Memorandum

To: Bassett Creek Watershed Management Commission
From: Barr Engineering Co. (Karen Chandler, P.E., and Jessica Olson, P.E.)
Subject: Item 5C – Consider Approval of 90% Plans for 2024 Ponderosa Woods Stream Restoration Project (CIP 2024 ML-22) – BCWMC November 20, 2024 Meeting Agenda
Date: November 13, 2024
Project: 23270051.62-6000-648

5C. Consider Approval of 90% Plans for 2024 Ponderosa Woods Stream Restoration Project, Plymouth (CIP 2024 ML-22)

FIGURE 1

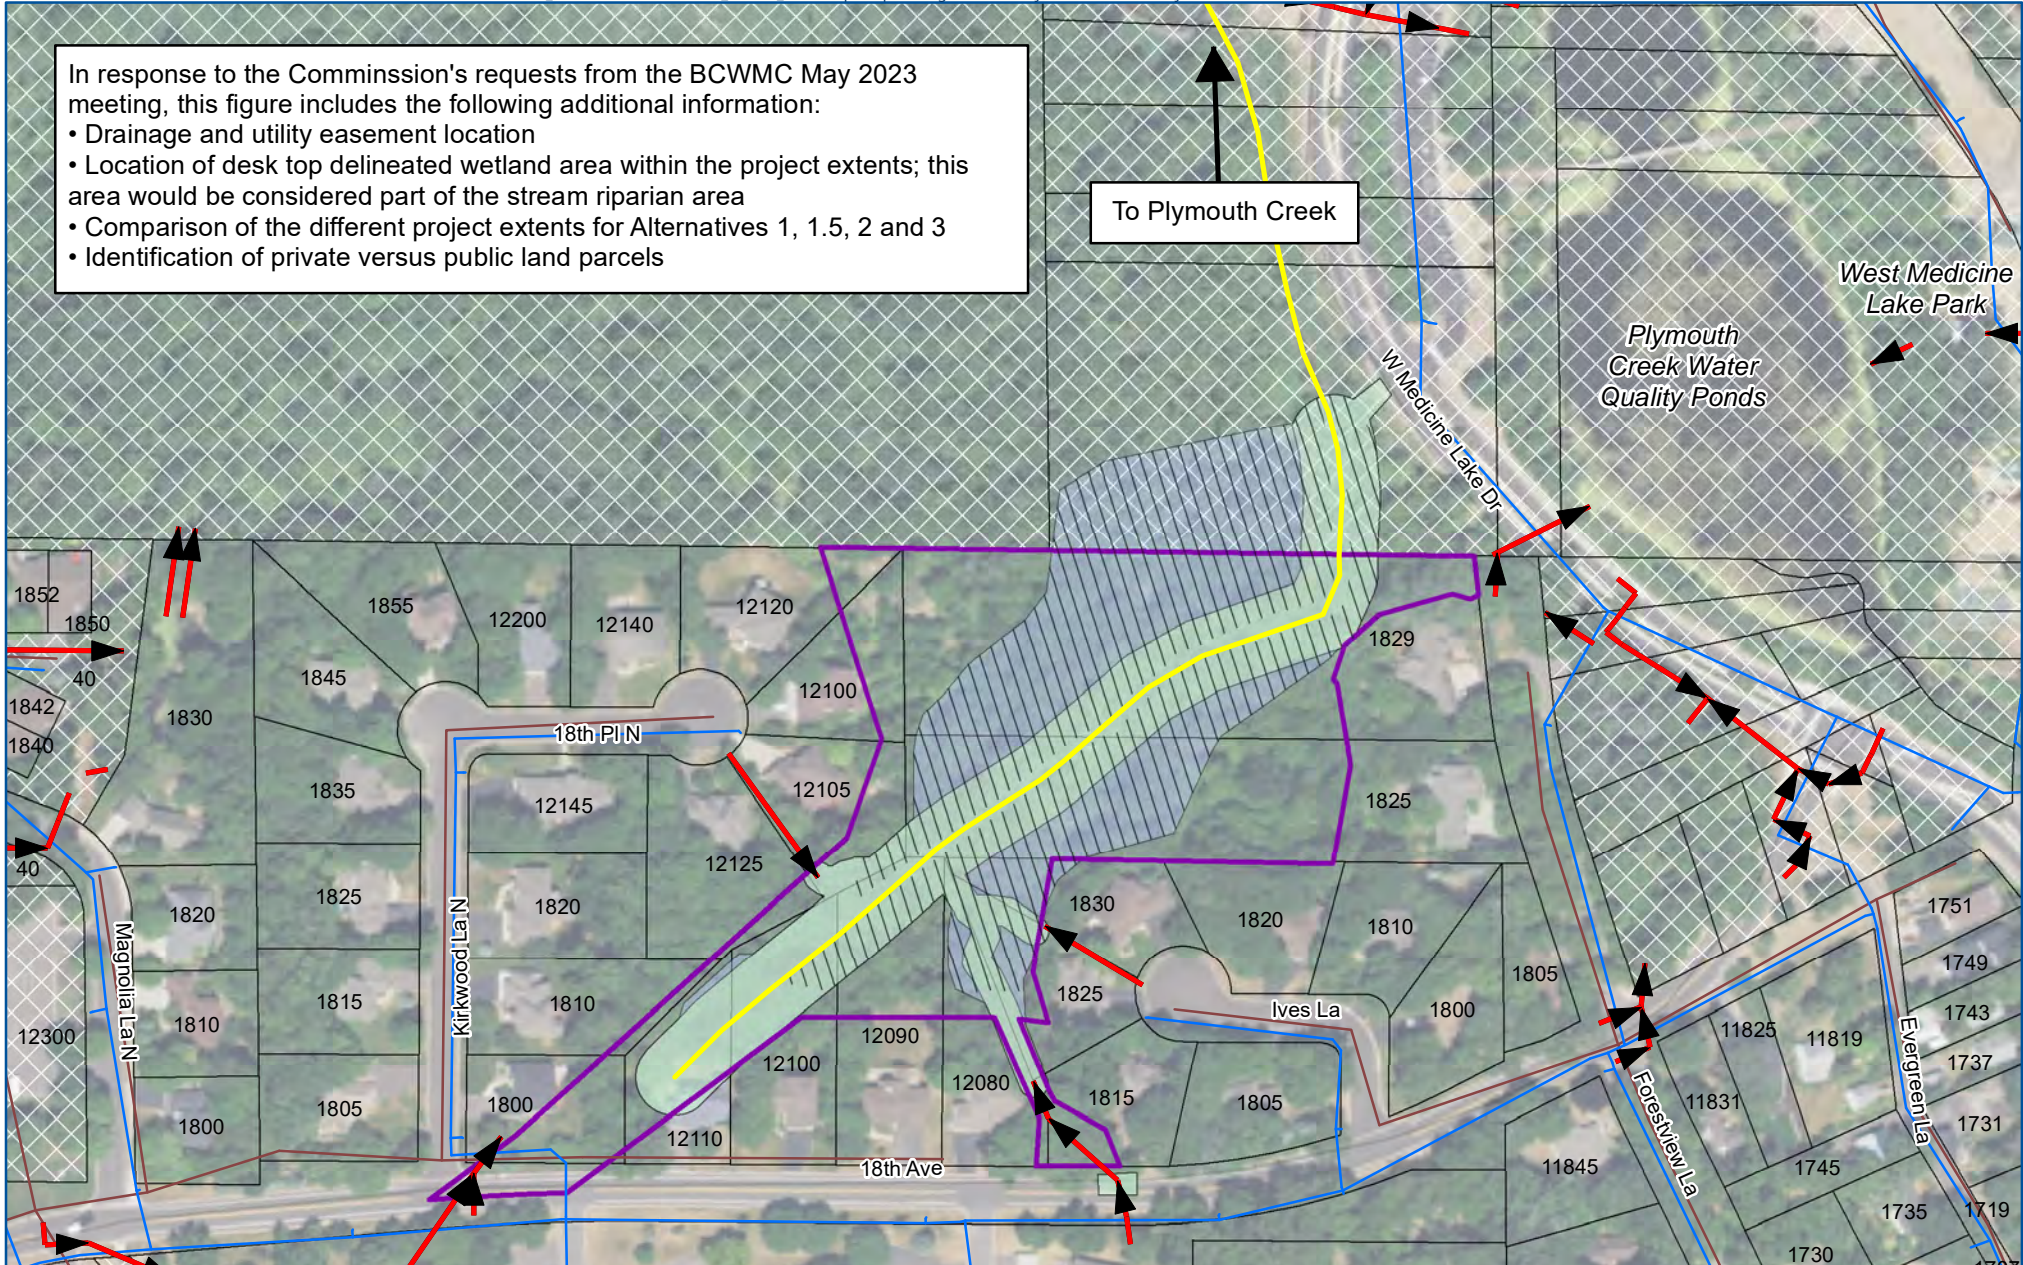
In response to the Commission's requests from the BCWMC May 2023 meeting, this figure includes the following additional information:

- Drainage and utility easement location
- Location of desk top delineated wetland area within the project extents; this area would be considered part of the stream riparian area
- Comparison of the different project extents for Alternatives 1, 1.5, 2 and 3
- Identification of private versus public land parcels

FIGURE 5-1

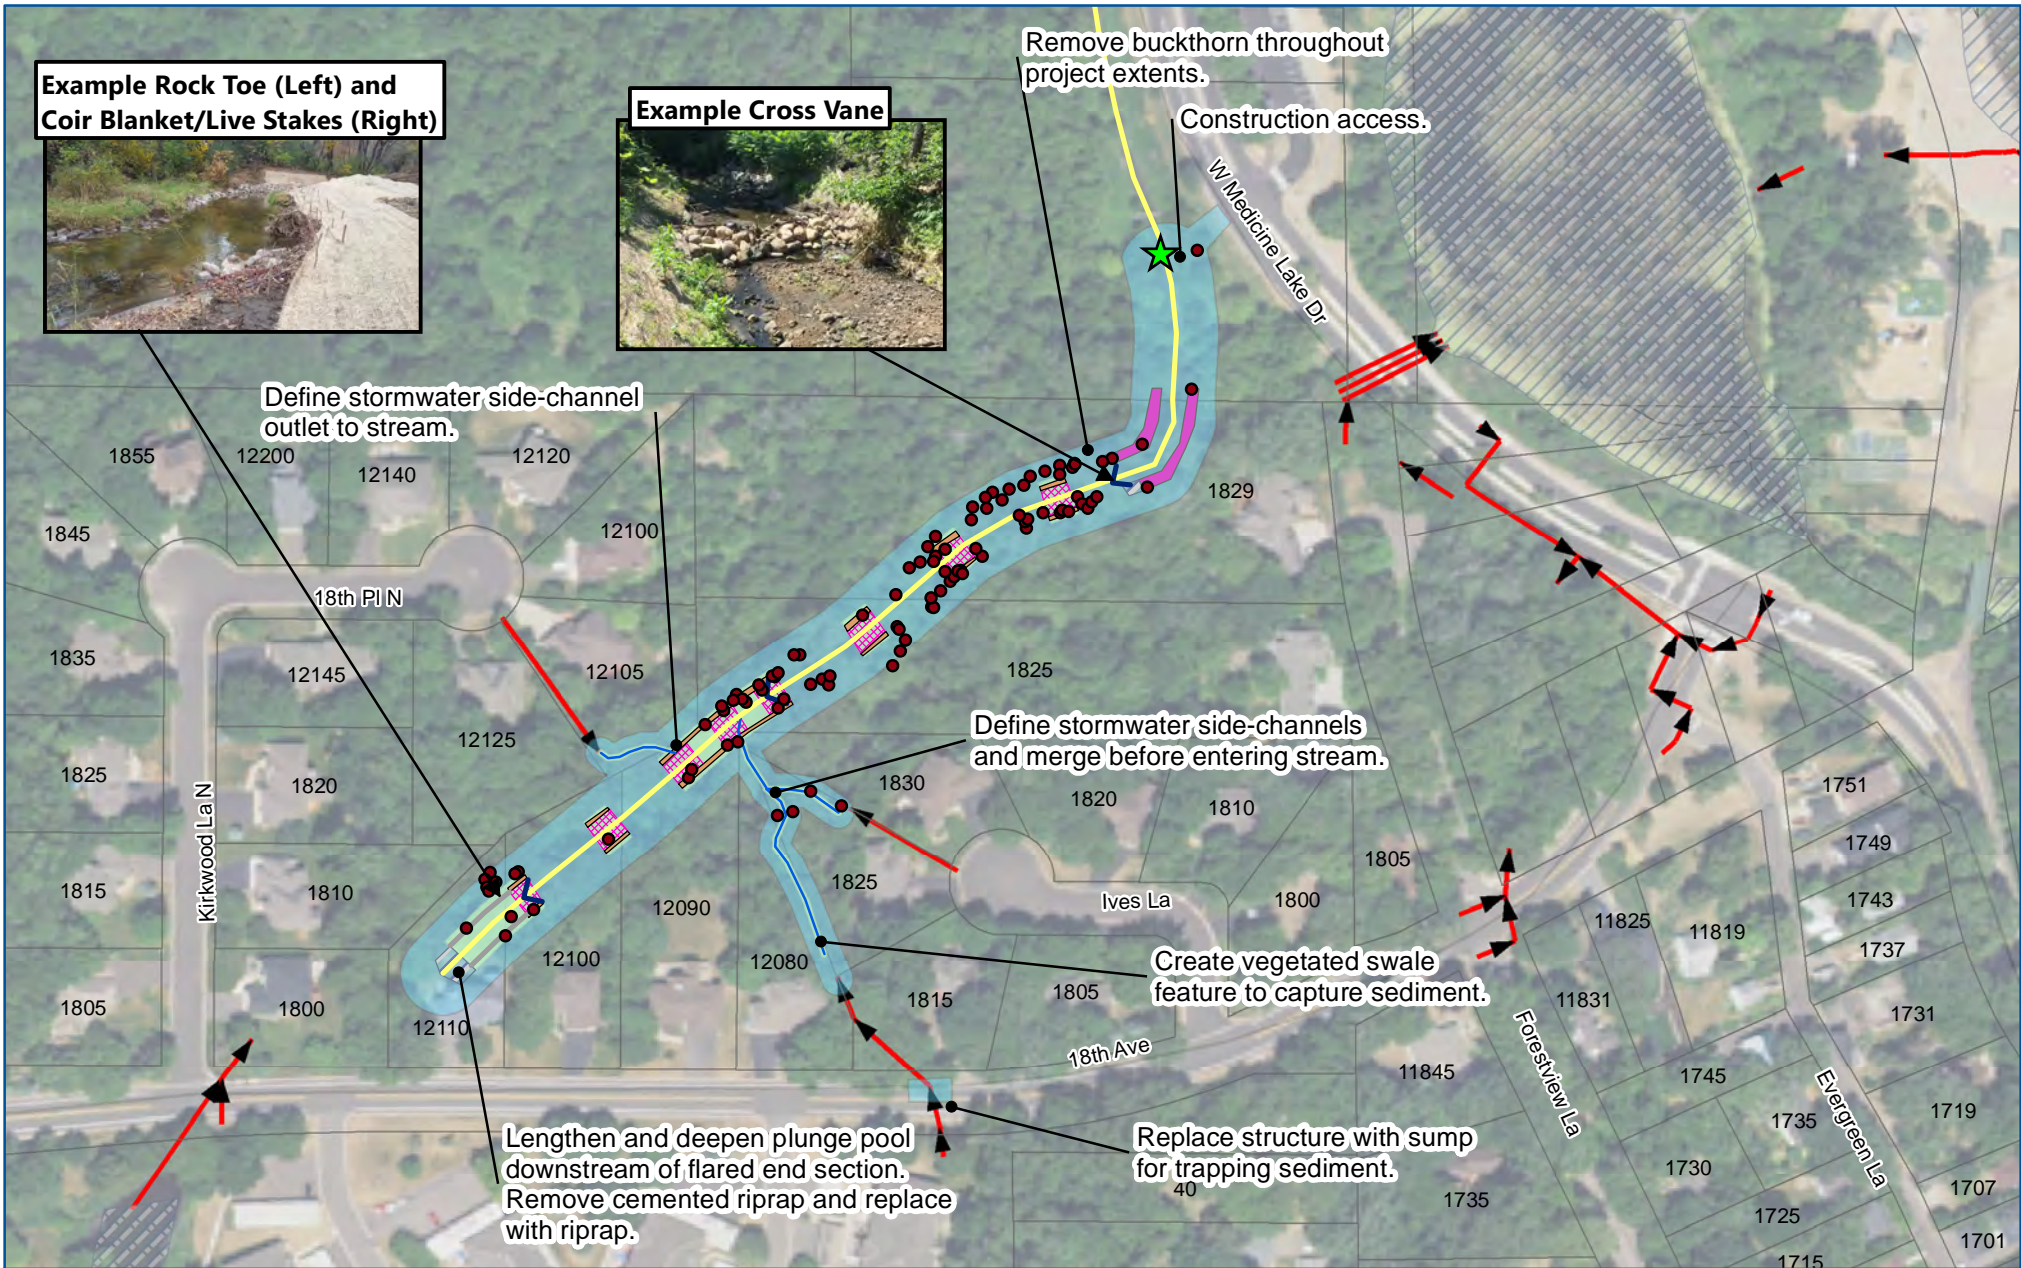
rock and other non-vegetative materials for each alternative. At their June 15, 2023 meeting, the Commission approved the implementation of "alternative 1.5" to stabilize streambanks, improve flow and reduce erosion in stormwater side channels, and remove buckthorn along the riparian buffer and within a 2-acre floodplain area at the downstream end of the project. Alternative 1.5 included stream stabilization with a combination of bioengineering and hard armoring, habitat improvement, including removal of dead and dying trees and buckthorn clearing, a stormwater sump structure for trapping sediment, and significant woody debris removal from the stream channel. Figure 1 from the June 8, 2023 memo to the BCWMC is included, highlighting the project area. Figure 5-1 from the Feasibility Study is also included, showing the design elements of the selected alternative.
